Access Compliance Report

Public Rights-of-Way

(Curb Ramps)

Intersection ID: 52590	Main Street: NOBLES_AV	Cross Street: TRIUMPH_DR	Location: SE
ADA ID: AEEAFC33E3BA	Ramp Type: Perp	Initial Pass/Fail: Fail	Overall Compliance: No
Severity Score: 13.75			
Codes/Mitigation Info/Possible Solution		Field Measurements/Component Compliance

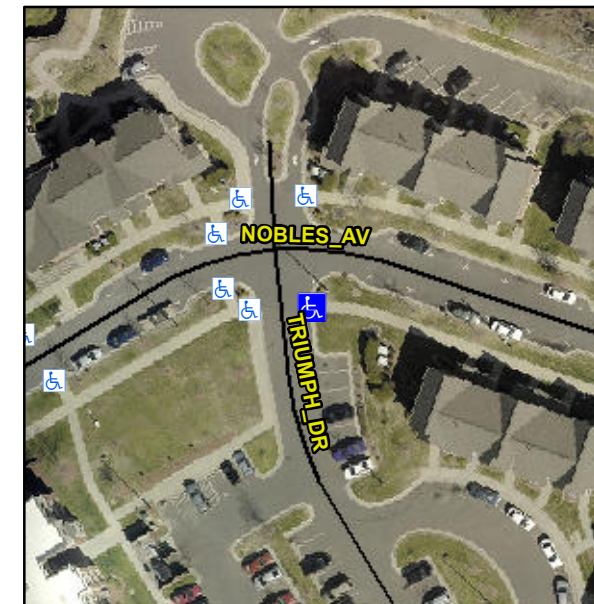
Not Found, R304.2.2, R304.5.3

Compliance	Description	Data	Compliance	Description	Data
N/A	Ramp Length (in)	72.0	No	Ramp Slope (%)	8.4
Yes	Ramp Width (in)	71.0	No	Ramp XSlope (%)	2.3
N/A	Flare Type LT	N/A	N/A	Flare Type RT	N/A
N/A	Flare Slope LT (%)	N/A	N/A	Flare Slope RT (%)	N/A
N/A	Flare Traversable LT?	N/A	N/A	Flare Traversable RT?	N/A
N/A	Landing Length (in)	N/A	N/A	DWS Provided?	N/A
N/A	Landing Width (in)	N/A	N/A	DWS Contrast?	N/A
N/A	Landing Slope (%)	N/A	N/A	DWS Length (in)	N/A
N/A	Landing X Slope (%)	N/A	N/A	DWS Full Width?	N/A
N/A	Landing Curb? (Y/N)	N/A	N/A	DWS Offset (in)	N/A
N/A	Shared Landing?	N/A			
N/A	Gutter Ponding?	N/A	N/A	Gutter Slope (%)	N/A
N/A	Gutter Lip Ht (in)	N/A	N/A	Gutter X Slope (%)	N/A
N/A	Painted X Walk1?	No	N/A	Painted X Walk2?	N/A
	X Walk 1 Direction	To W		X Walk 2 Direction	N/A
N/A	X Walk 1 Width (in)	N/A	N/A	X Walk 2 Width (in)	N/A
	X Walk 1 Slope (%)	1.2		X Walk 2 Slope (%)	N/A
	X Walk 1 X Slope (%)	0.7		X Walk 2 X Slope (%)	N/A

Remove & Replace Entire Ramp.
